## IMPORTANT SAFETY RECALL

**Re: Safety Recall – Smart-Steer 2.0 Self-Steer Axle with 702887 Steer Arm**

# SERVICE BULLETIN #SB015

## Subject: SMART-STEER 2.0 Axle with 702887 Steer Arm

## Steer Arm Welding Specifications

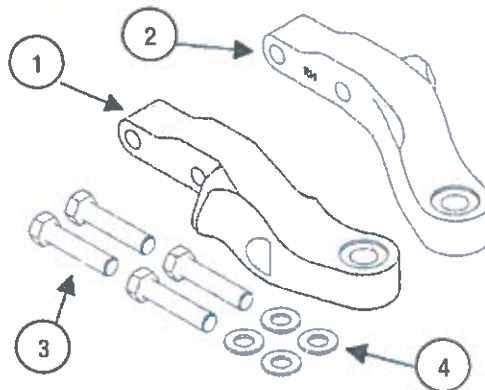
1. Remove the existing steer arms and mounting hardware.
2. Clean mounting surface and surrounding surfaces to prepare for mounting of the new bolt-on steer arm and additional welds.
3. Grind a 3/16" chamfer along the mounting face edge (see page three for location & detail).
4. Mount new design steer arms (Part # 703293-LH/RH) with supplied hardware and torque to 400 ft-lbs.
5. Add welds as shown on page three of this bulletin.
